**From:** Wooldridge, John  
**Sent:** Thursday, June 11, 2020 12:43 PM  
**To:** Chris E. Howard; James Howard  
**Cc:** Heim, Kimber; Norton, Harvey; Kadakia, Nikunj  
**Subject:** 110412 FAI 037 Safety Project Authorization (NTP) for Appraisals  
**Attachments:** 110412 FAI 037 Authorization 34127 HLS 061120 Executed.pdf

**Subject:** RE: FAI-37-6.34 Preliminary Right of Way Plans (PID No. 110412)

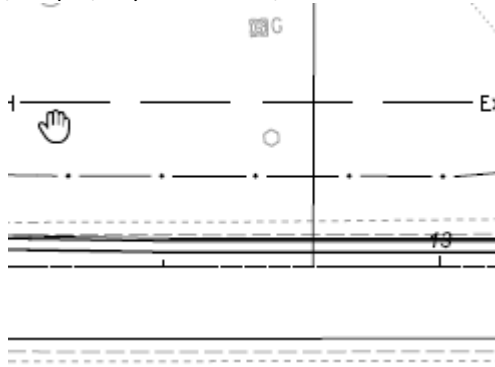
- Missing sheet 20 of 37 as Luke stated.
- Page 21/36 (22/37) Parcel 11-SH shows "Utility Pole Save" for private light poles. I would have them removed as ODOT will need to pay for them anyways (in take area) and would need to do a permit (not recommended) for the poles that are very close to the fence needing removed. Same Parcel has three of those poles (not 2) and also has a small sign near the fence that was not picked up on these plans:
